In the Matter of
Long Island Lighting Company
(Shoreham Nuclear Power Station, Unit 1)
Docket No. 50-322 (OL)

In the report filed on August 23, 1982, the NRC Staff identified the pages of the Shoreham SER that are relevant to the testimony on QA/QC (SC 12-15). Enclosed, for the convenience of the Board and parties, are copies of those pages.

17 QUALITY ASSURANCE

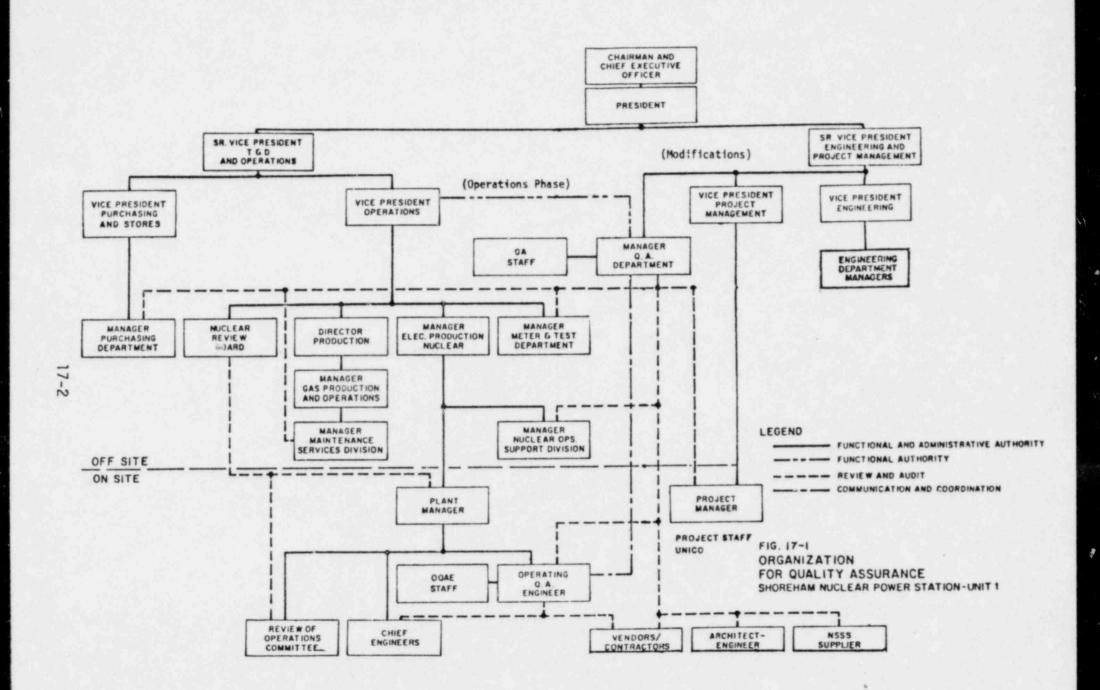
The structure of the organization responsible for the operation of Shoreham and for the establishment and execution of the operations phase quality assurance program is shown in Figure 17-1. The Vice President of Operations has been delegated overall responsibility for the safe and reliable operation of all Long Island Lighting Company generating plants. He is responsible for the establishment, implementation, and effectiveness of the operational quality assurance program, policies, goals, and objectives. These responsibilities are carried out through: the Quality Assurance Manager, Manager - Electric Production-Nuclear, the Plant Manager, and the Director of Production.

The quality assurance department is supervised by the Quality Assurance Manager. He reports functionally and administratively to the Senior Vice President, Engineering and Project Management during modification activities and functionally to the Vice President of Operations for direction during operating phase activities. The Quality Assurance Manager is responsible for establishing and implementing the Long Island Lighting Company quality assurance program at Shoreham as described in the Long Island Lighting Company Quality Assurance Manual. He is assisted in carrying out his responsibilities by onsite and offsite quality assurance personnel.
